# Technical Advisory Bulletin (TAB)

Bulletin #: TBMELCO20A

Product: Melco EMT16, BRAVO

**Subject:** P/N 34504 Thread Cutter Blade  
(P/N 34345 Rotary Hook), (P/N 34666 Thread Cutter Kit)

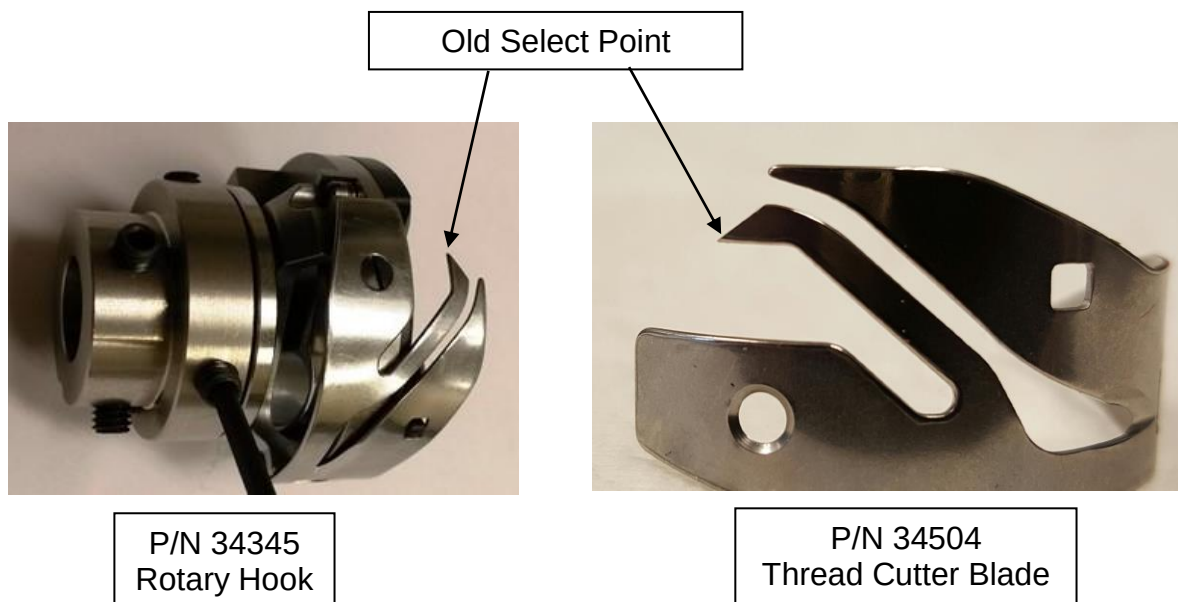
Trimming issues related to miss-selects of the bobbin thread have been reported resulting in customer complaints and increased warranty costs. The bobbin thread miss-selects are occurring because the “select point” on the Thread Cutter Blade, P/N 34504, is not optimally positioned for proper engagement into the thread select window (triangle) during the trim operation.

Notice that the old Select Point is defined by a secondary machining operation that leaves a sharp end/point on the “Select Blade”.

The Thread Cutter Blade, P/N 34504, design was modified so that the “select point” is positioned better in the thread select window during the trim operation, thereby improving bobbin thread selection and trimming performance.

Notice that the new Select Point is now defined by the original rounded end of the “Select Blade”. The Select Point is now just moved further towards the rear of the hook.
